# SERVICE BULLETIN

Ride Name: Fire Ball    Affected Serial Nos.: All units

Bulletin No.: L03-006  
Release Date: 7/5/06  
Effective Date: Immediately  
Supercedes: N/A  
Completion Date: N/A  
Page: 1 of 5

**Abstract Of Issue:**  
Restraint Bumper Installation

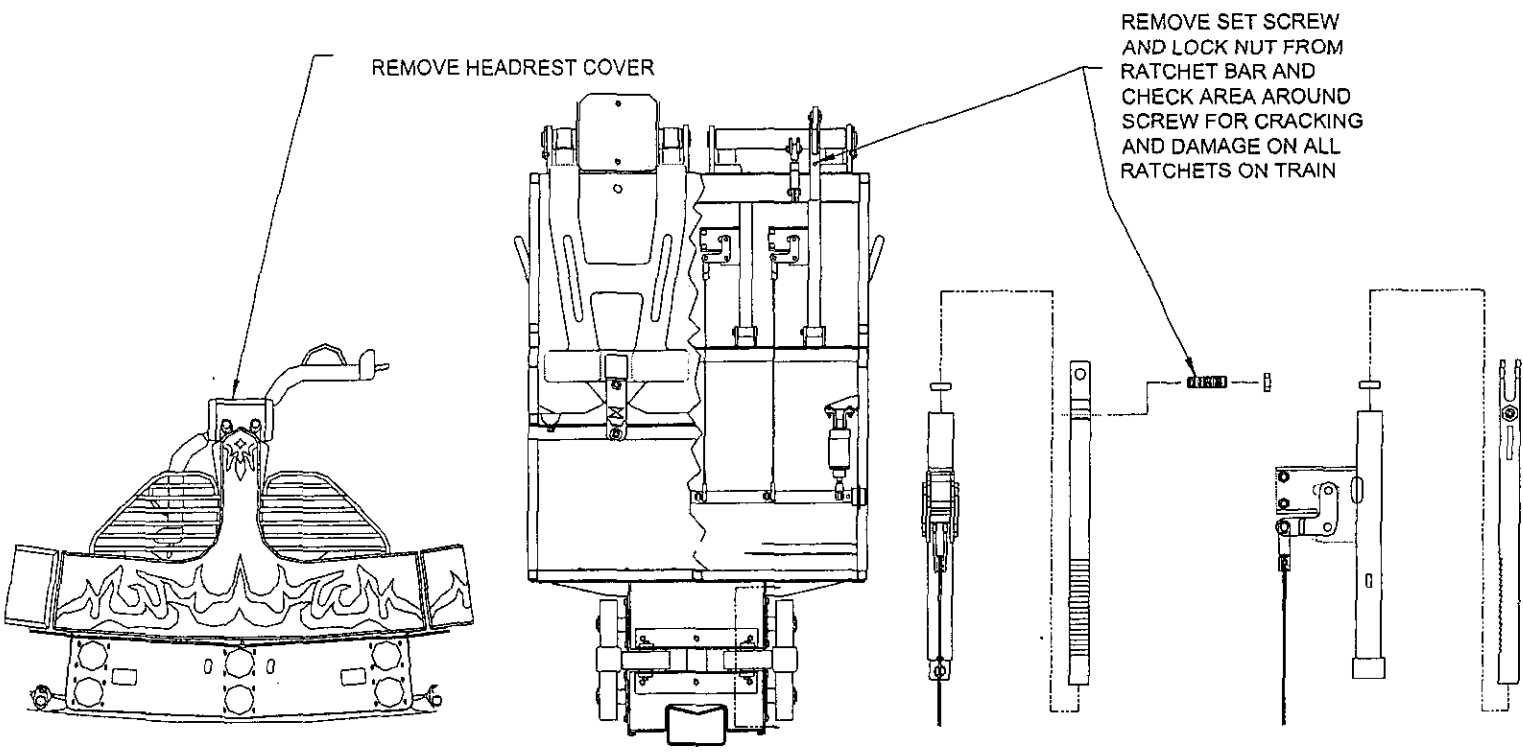
1. Remove all head pad covers.

2. Remove stop set screw and locknut from upper portion of ratchet assembly.
  3. Add bumper assembly under over the shoulder restraint and weld in place. (see instructions)
  4. Welding must be completed by AWS D1.1 certified welder.
  5. N.D.T inspection of bar at the point where the stop set screw was located is required.
  6. If upon inspection there are signs of bending and or cracking replacing the ratchet bar is necessary.
  7. A copy of the inspection report must be sent to Larson Intl, Inc.
  8. This modification must be completed no later than July 21, 2006. If modifications & N.D.T. are not complete by this date the ride must be taken out of service until testing & modifications are complete
-

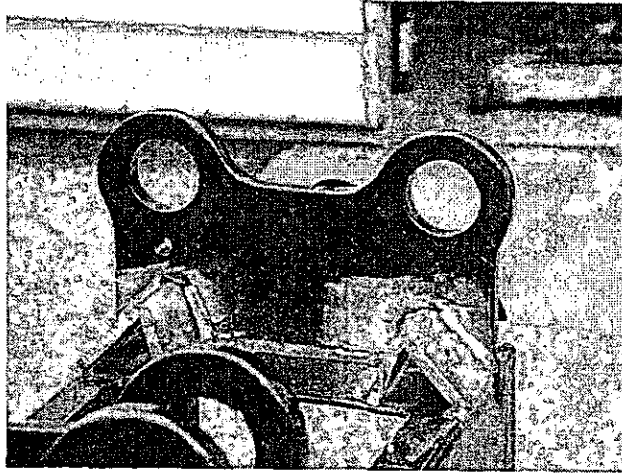
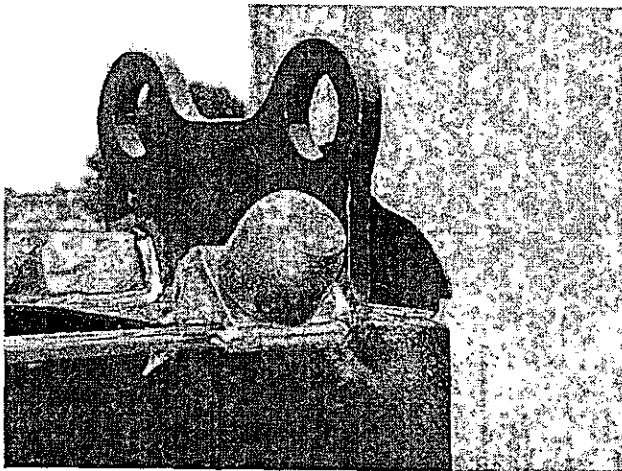
Mount brackets flush with channel.

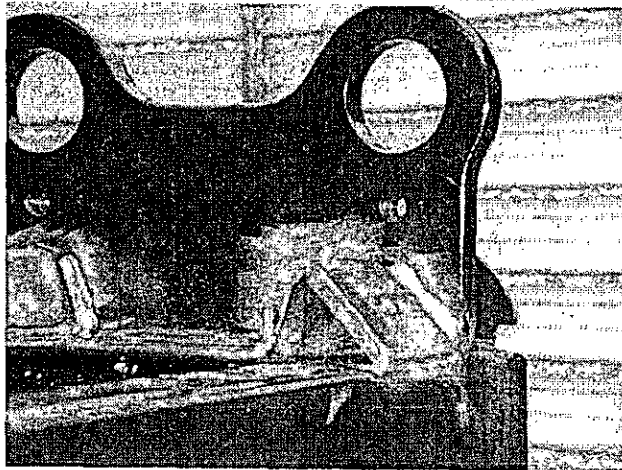
After weldment and painting are complete screw in rubber bumper as shown.
